SITE ADDRESS: 18 & 20 The Serpentine, Bilgola Beach.

PROJECT- Addendum to Arboricultural Impact Assessment (AIA) in relation to Development Application No. DA2023/0374 - Construction of a studio and car parking structure.

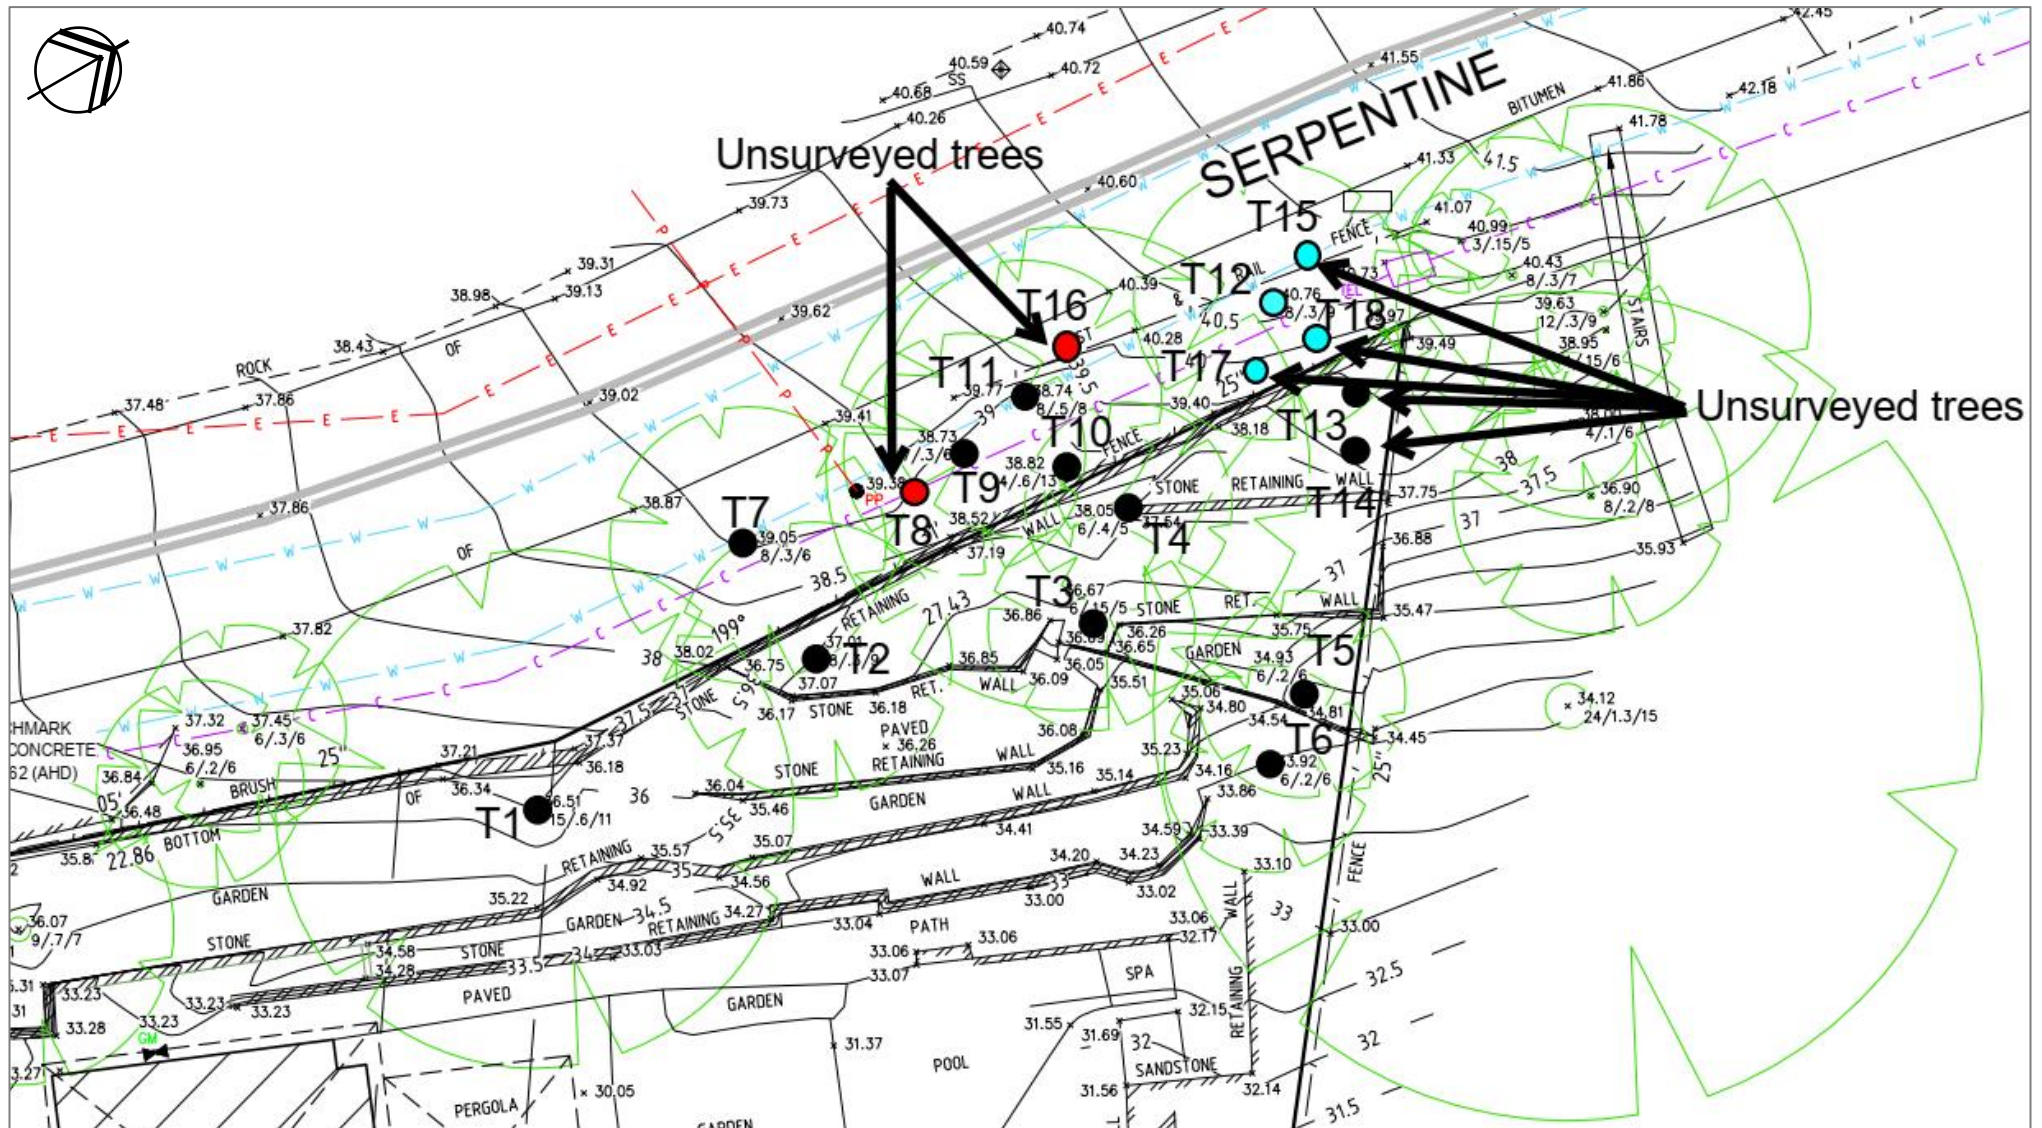
Several suckering¹ *Casuarina glauca* (Swamp she-oak) are located within the road reserve. Not all these suckers were discussed within the original AIA as they were outside the zone of impact for the proposal, and they had not been plotted within the Survey Plan. Tree 8 was marked up manually within the Survey Plan by Treeism for the original AIA. An additional four (4) suckers impacting the view line have been identified in the recent inspection (Tree 15, 16, 17 and 18, see Appendix B).

Tree 8 has the bulk of its canopy within the viewline, the pruning could not be carried out in compliance with AS4373, the required pruning would render the tree not viable for retention. Removal of Tree 8 is now recommended.

Tree 9 and Tree 11 have no canopy within the view line, as such, these trees are to be retained and protected. Previously recommended removal of Tree 10 will aid in providing additional clearances for sight lines.

Tree 16 is located very close to the roadway edge and has a at base diameter of approximately 60mm, the canopy obscures vision and as such removal is recommended.

Minor crown-raise pruning of Tree 12, 15, 17 and 18 is recommended to allow clear vision. A maximum branch diameter of 30mm at the branch junction and 10% of total live canopy is all that is required to facilitate clear vision.

Cut to ground level Tree 8 and Tree 16. Given the suckering nature of the discussed trees DO NOT poison the stumps (as this can affect the parent trees).

Tree 9 and Tree 11 are to be retained and protected, no pruning is deemed necessary.

Pruning of Tree 12, Tree 15, Tree 17 and Tree 18 is to be in accordance with AS4373-2007 Pruning of amenity trees, a maximum 10% of total live and canopy and branch diameter of 30mm is to be removed.
